Grand Bay NERR Outdoor Classrooms

Addendum #3

18 January 2017

1 ALTERNATE FOUNDATION AND FRAMING
PLAN
1/4" = 1'-0"

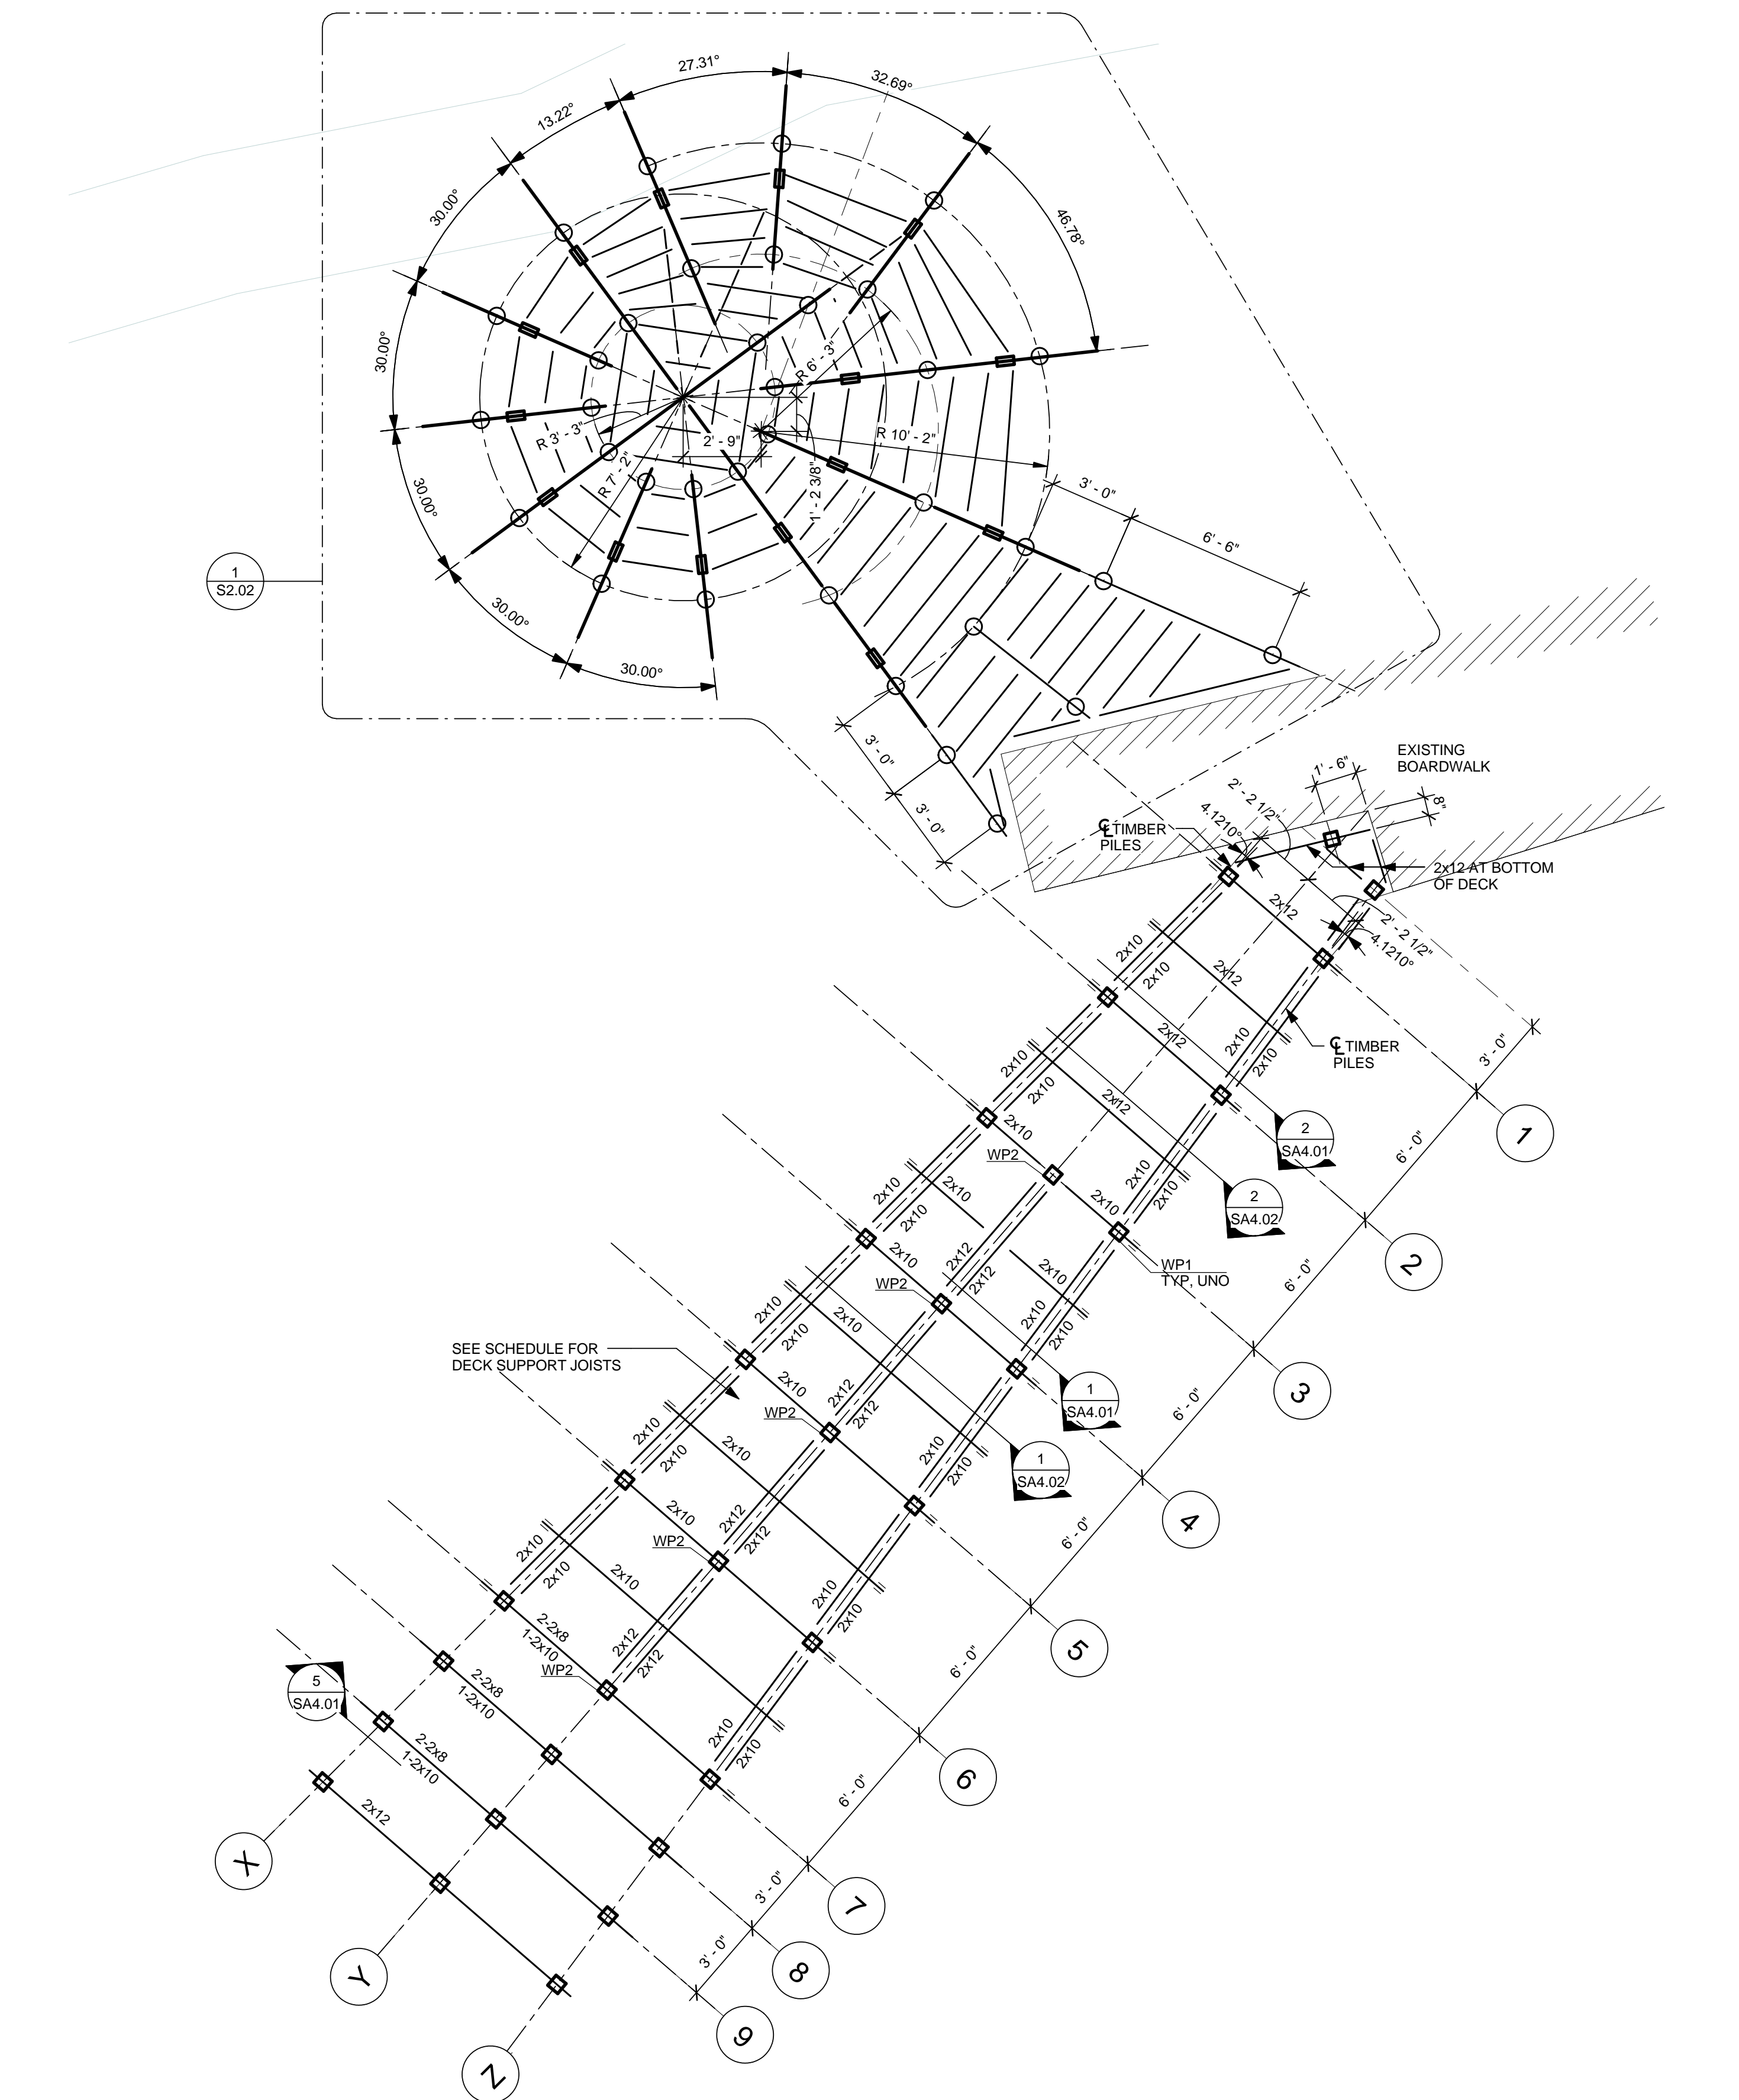
The Geotechnical Report (sent in Addendum #2) indicates an option for the foundation design at the ramp portion of the project. Attached please find the revised and new structural drawings, which offer an alternate detail for supporting the ramp area of the outdoor classroom with wood piles. It is left to the Contractor's discretion which method will result in the lowest and best bid, but either foundation design is acceptable if provided as indicated in the drawings and specifications.
